City of Sugar Hill
Planning Staff Report
DRB-CBD 21-004

DATE: February 2, 2022; **Updated 2/10/2022**
TO: Mayor and Council, Design Review Board
FROM: Planning Director
SUBJECT: Central Business District (CBD) Design Review
Mixed-use Development
1450 Peachtree Industrial Boulevard

SUGAR HILL II
MIXED-USE DEVELOPMENT

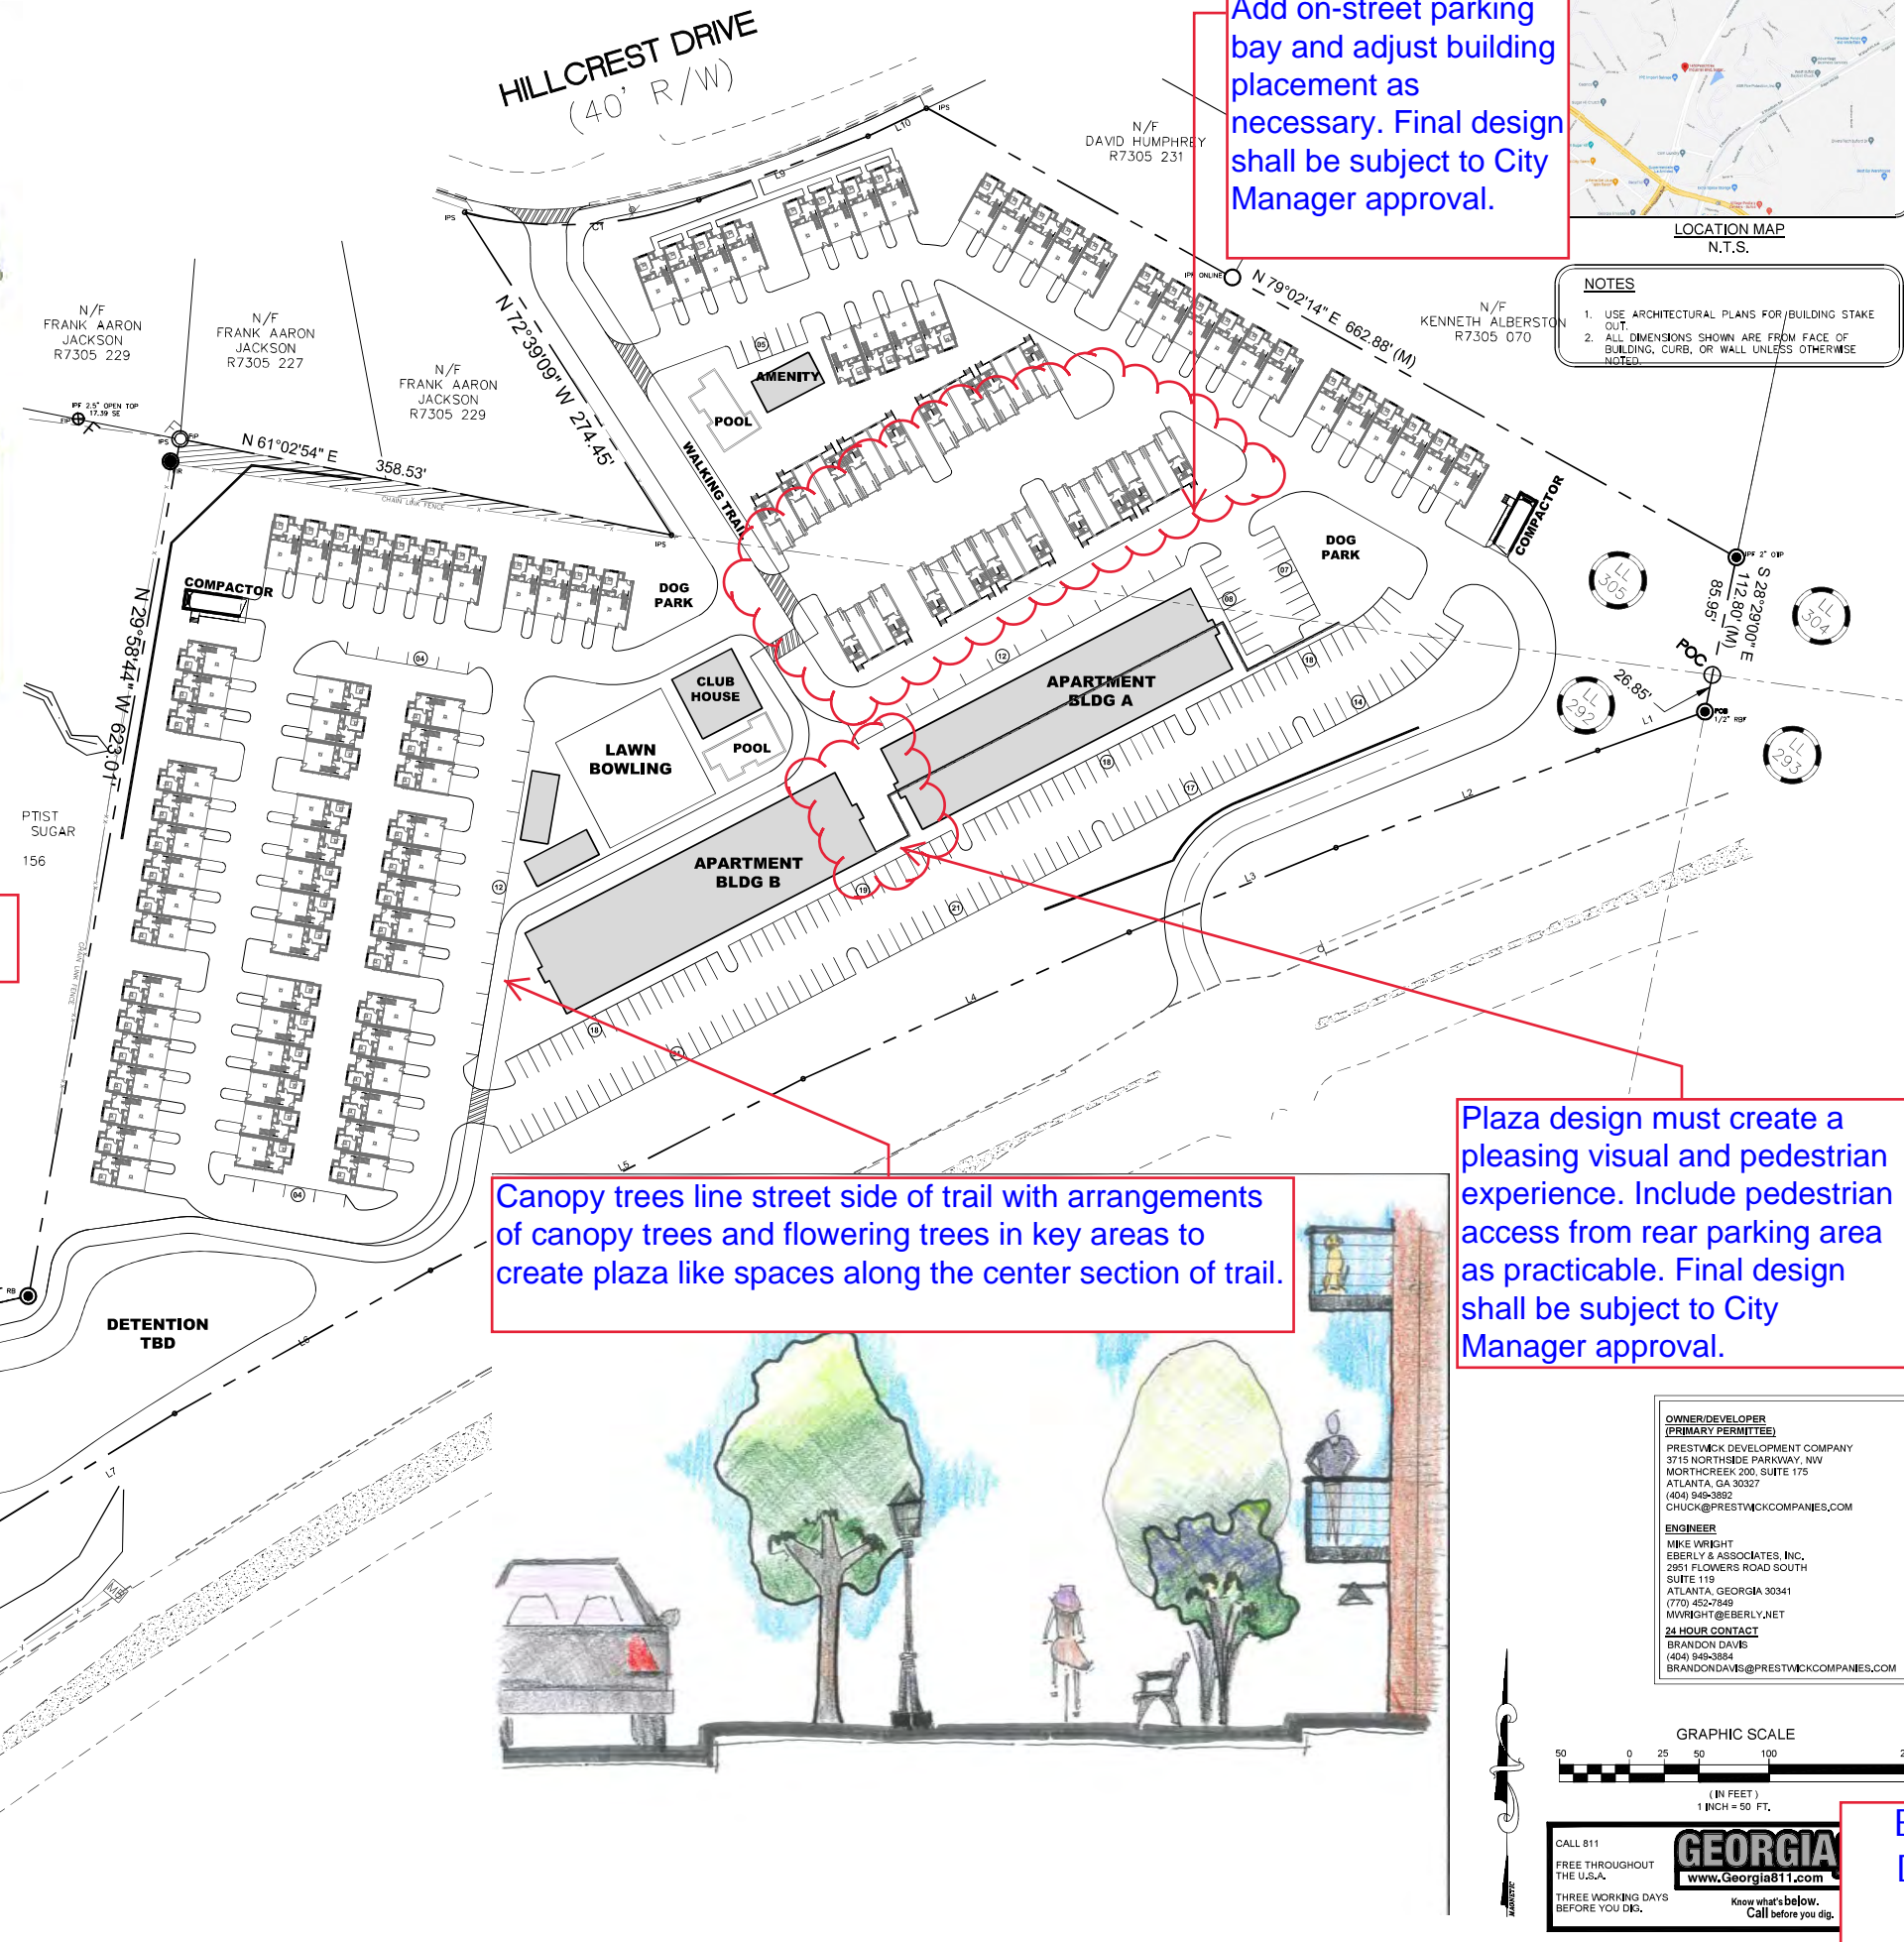
Canopy trees line both sides of trail entering the site.
